Union of Concerned Scientists

June 12, 2002

SUBJECT: QUESTIONS FOR DAVIS-BESSE MANUAL CHAPTER 0350 PANEL

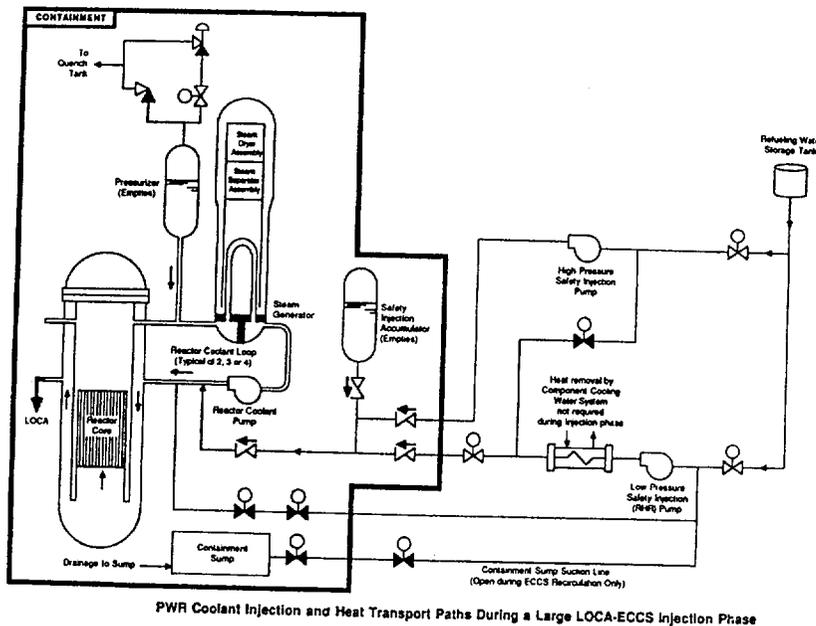
The schematic illustrates the systems involved following a loss-of-coolant accident. The LOCA is represented by the opening on the left side of the reactor vessel allowing cooling water to pour out into the containment building where it drains to the containment sump.

The high pressure safety injection pumps and the low pressure safety injection pumps (one each shown on the right portion of the schematic) initially supply water from the refueling water storage tank to the reactor vessel to compensate for the lost inventory. Thirty minutes to an hour into the accident, the refueling water storage tank empties. Operators close valve (shown as the white bow-ties on the schematic) and open other valves (the black bow-ties) to allow the pumps to take water from the containment sump and deliver it to the reactor vessel.

- UCS-02a **Will the plant-specific evaluation of GSI-191 vulnerability recommended by the NRC staff in its presentation to the ACRS in September 2001 be completed for Davis-Besse prior to restart?**
- UCS-02b **If not, would the NRC staff not be guilty of the exact same, or at least eerily similar, tolerance of degraded conditions that caused the current problem at Davis-Besse?**
- UCS-02c **Will all of the boric acid deposited inside the reactor containment at Davis-Besse be found and removed prior to restart?**
- UCS-02d **If not, what assurance exists that this debris won't be transported to the containment sump and contribute to sump failure?**
